CITY OF ALBUQUERQUE

RE: **Jackson Middle School
Grading and Drainage Plan
Engineer's Stamp Date 11-11-16 (File: J21D029)**

Based upon the information provided in your submittal received 12-28-2016, the above referenced plan is approved as noted for Building Permit:

**BUILDING A
~CAFETERIA~
GRADING & DRAINAGE
PLAN**

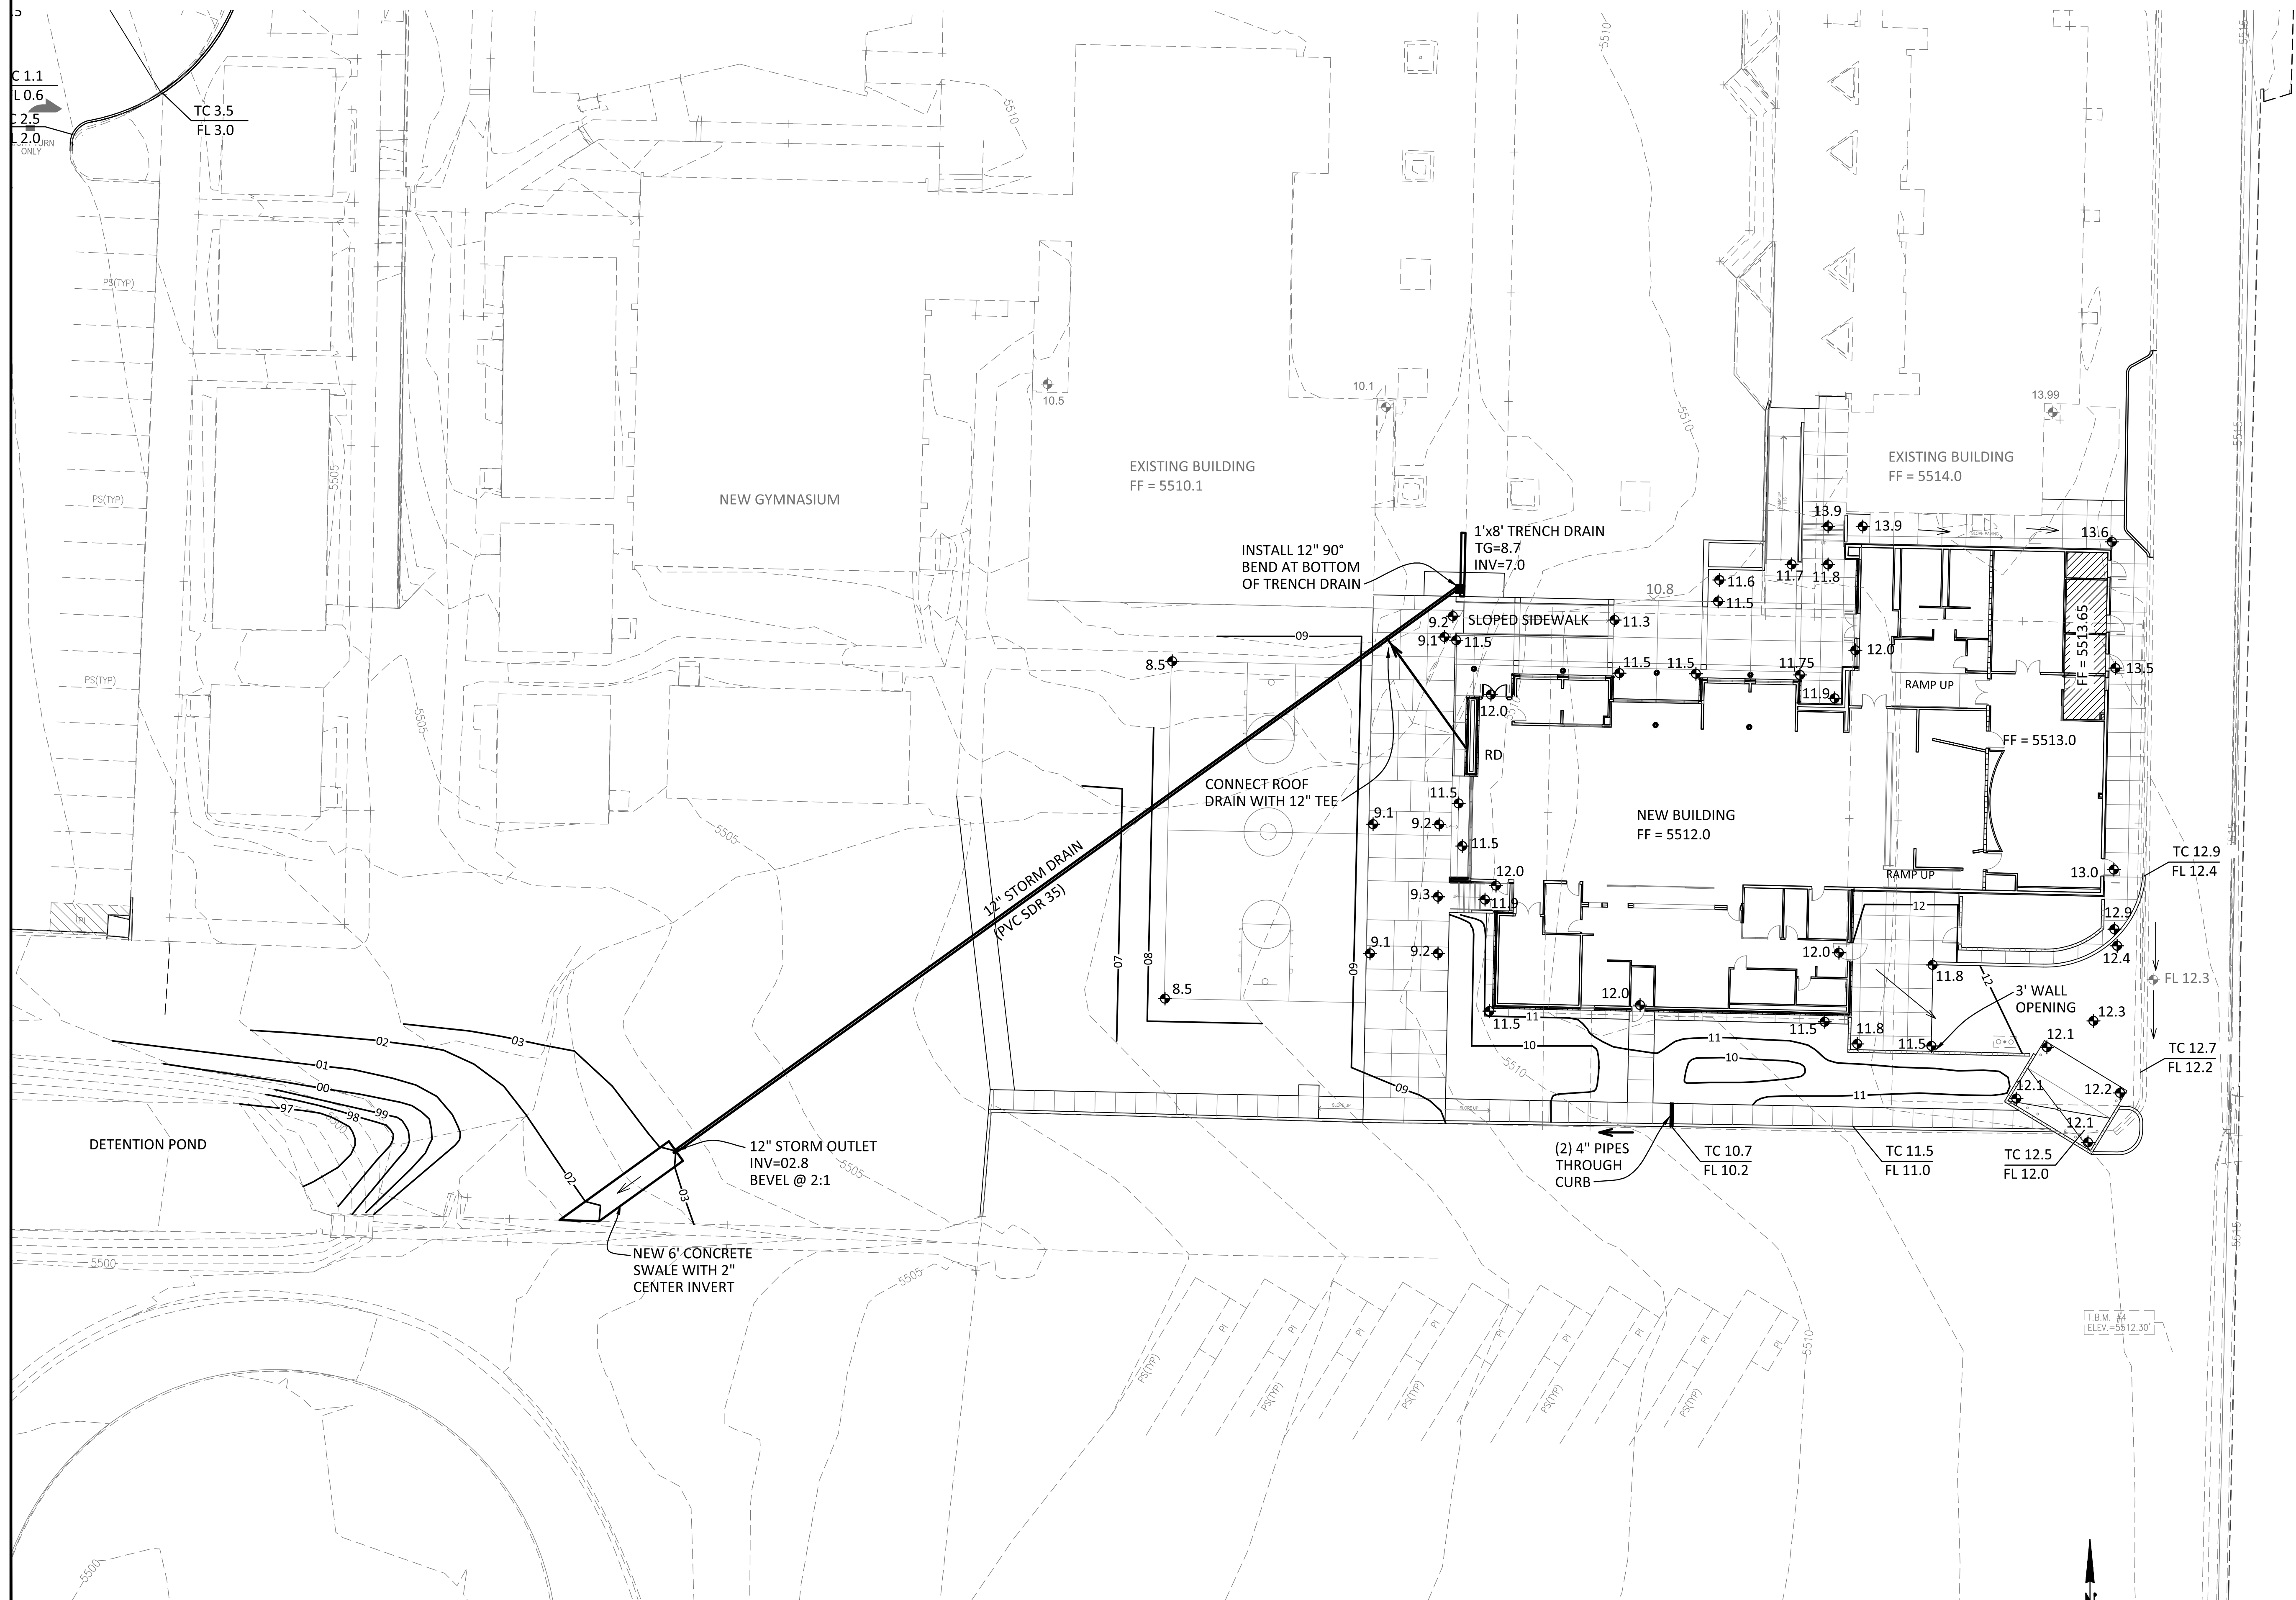
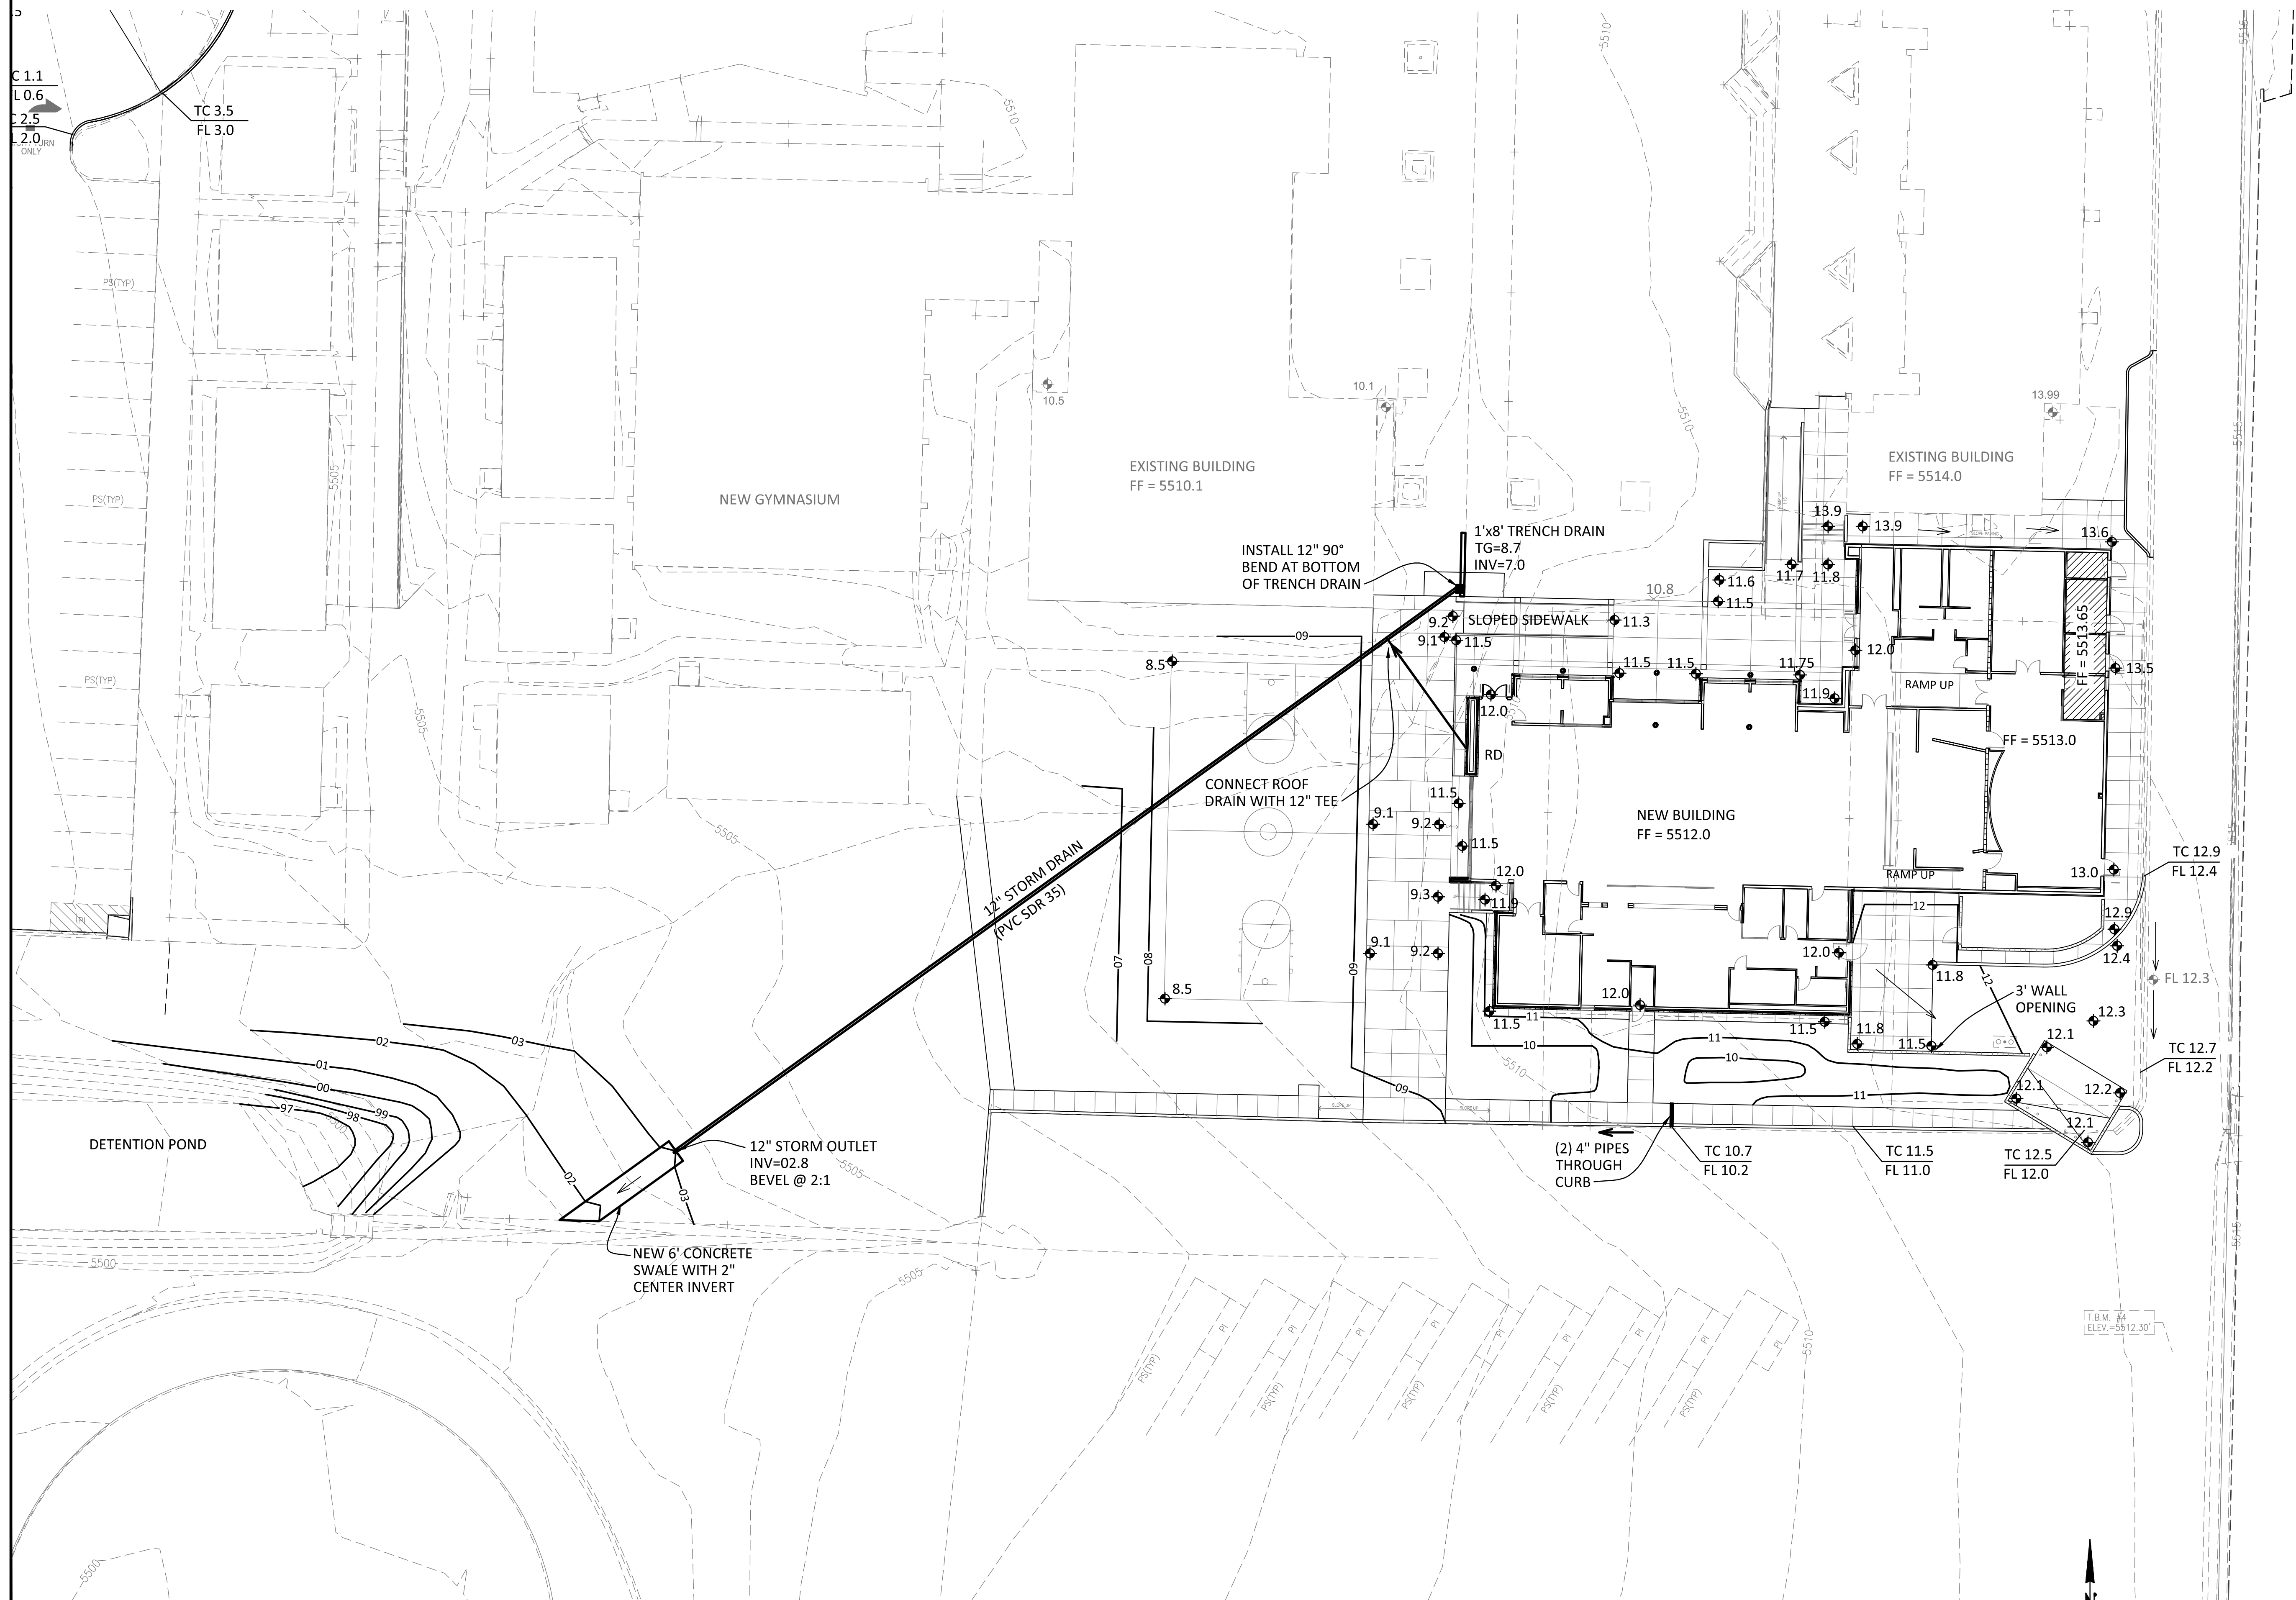
1. The Drainage Approach concludes with flows from the shallow depressed landscaping area being directed northward into a parking area and toward Comanche. No mention of directing flows into the storm drain and southwest towards the detention pond is made. Clarify the last portion of the Drainage Approach to match what is shown on drawings.

The approach as shown on drawings, acceptably conveys flows from the impervious areas through storm drain or overland, to the enlarged detention pond, whose outfall is Blume Street on City Right-of-Way. Additionally, it is recommended that erosion along the existing concrete rundown to the detention pond is corrected as part of this work.
